<b>APPLICATION FOR PERMIT TO DRILL</b>				5. MINERAL LEASE NO: <b>Fee</b>	6. SURFACE: <b>Fee</b>
1A. TYPE OF WORK: <b>DRILL</b> <input checked="" type="checkbox"/> <b>REENTER</b> <input type="checkbox"/> <b>DEEPEN</b> <input type="checkbox"/>				7. IF INDIAN, ALLOTTEE OR TRIBE NAME: <b>N/A</b>

2. NAME OF OPERATOR: <b>Prima Oil &amp; Gas Company</b>				9. WELL NAME and NUMBER: <b>Scotfield-Thorpe 25-32</b>	
3. ADDRESS OF OPERATOR: <b>1099 18th St, Suite 400</b> CITY <b>Denver</b> STATE <b>CO</b> ZIP <b>80202</b>			PHONE NUMBER: <b>(713) 739-7300</b>	10. FIELD AND POOL, OR WILDCAT: <b>undesignated Wildcat</b>

**OPERATOR:** Prima Oil and Gas Company  
**WELL NAME & NUMBER:** Scotfield-Thorpe 25-32  
**API NUMBER:** 43-007-30988  
**LOCATION:** 1/4,1/4 NWSW Sec:25 TWP: 12S RNG: 7E 1627 FSL 1017 FWL

- Please replace the following plats and drawings with the attached revised plats and drawings:
1. A-2, Pad layout, the pad and pit has been expanded to accommodate equipment and fluids
  2. C-1, Cuts and Fill volumes have changed to reflect a larger pad and pit design

Casing Schematic

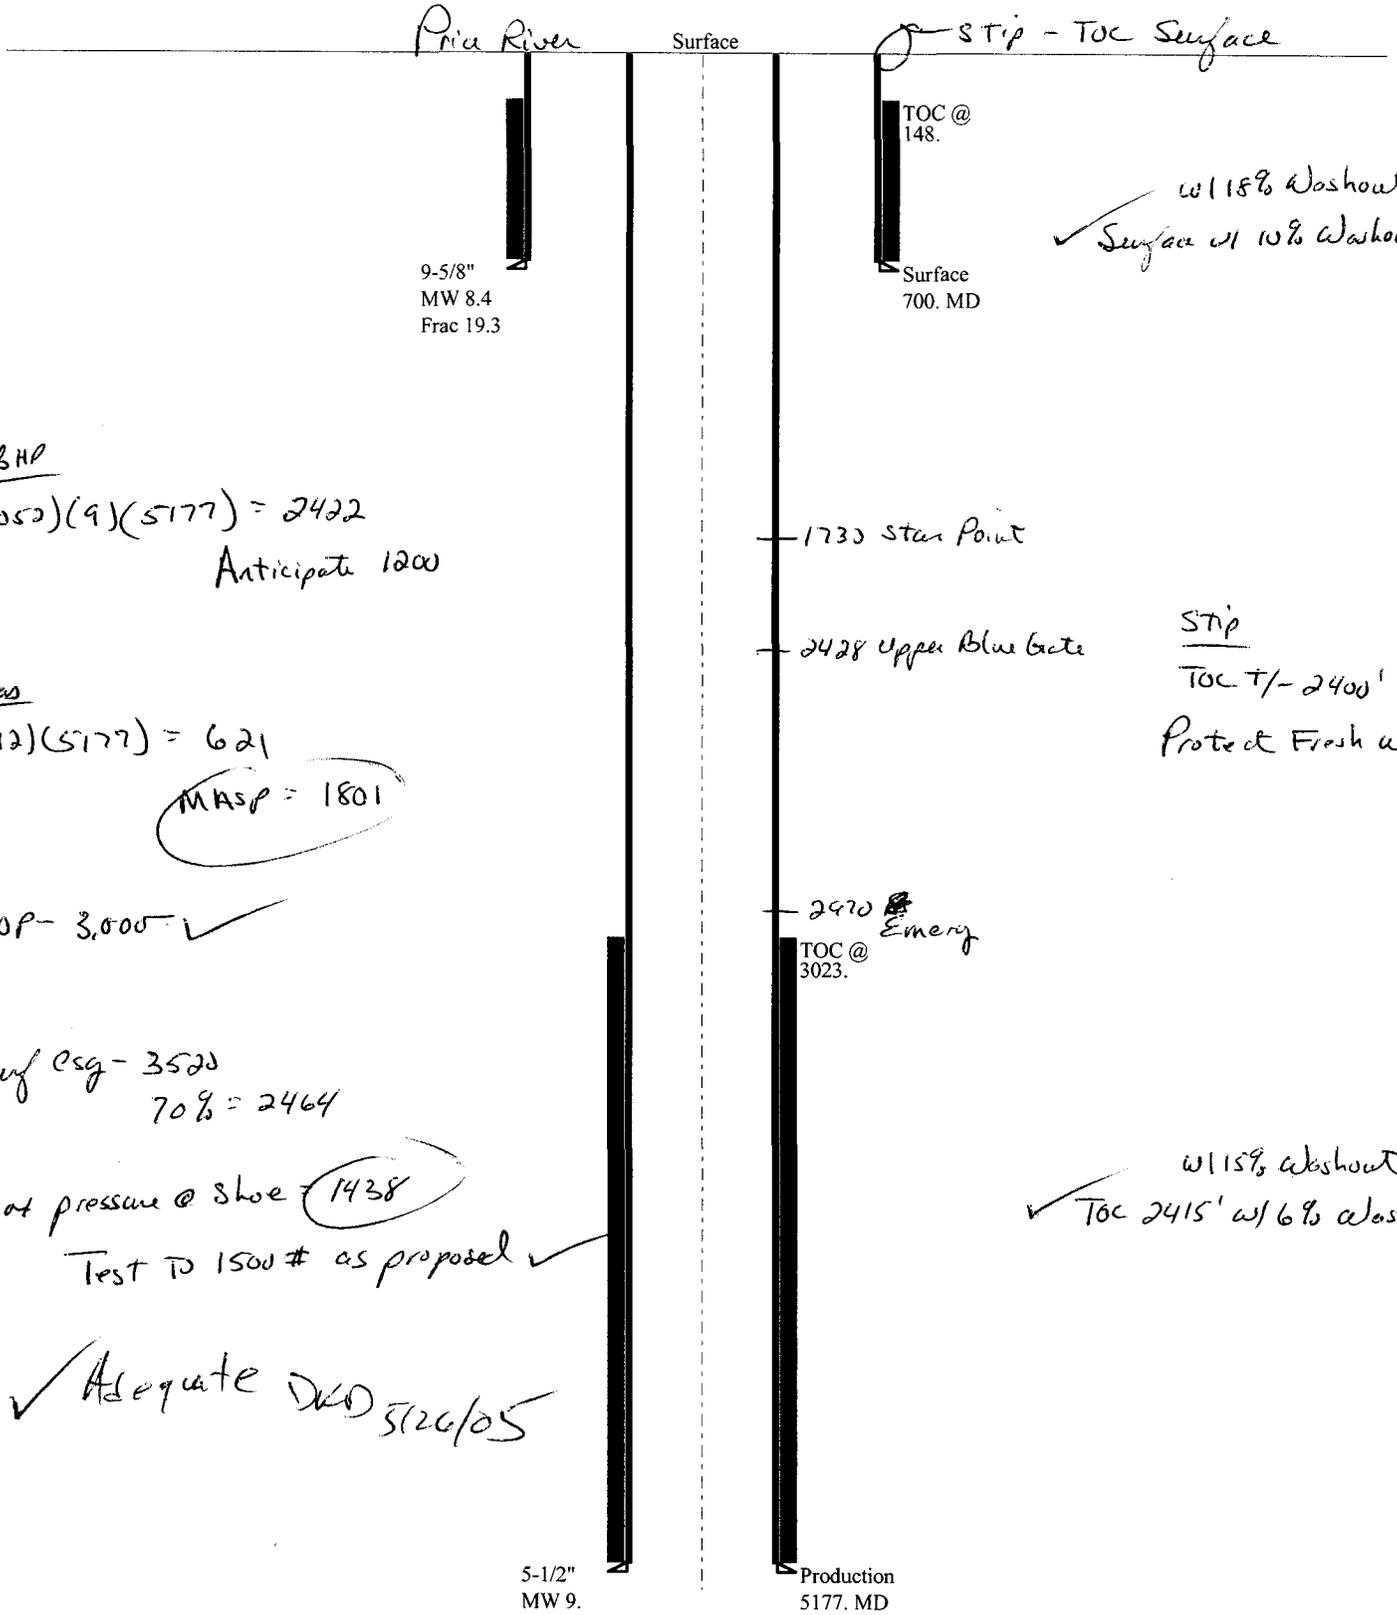
BHP  
 $(.052)(9)(5177) = 2422$   
 Anticipate 1200

Gas  
 $(.12)(5177) = 621$   
 MASP = 1801

BOP - 3,000 ✓

Surf csg - 3520  
 70% = 2464

Max pressure @ shoe = 1438  
 Test to 1500# as proposed ✓

2970 Emerg  
 TOC @ 3023.

STIP  
 TOC +/- 2400'  
 Protect Fresh Water

✓ w/ 15% washout  
 TOC 2415' w/ 6% washout

✓ Adequate DKO 5/26/05
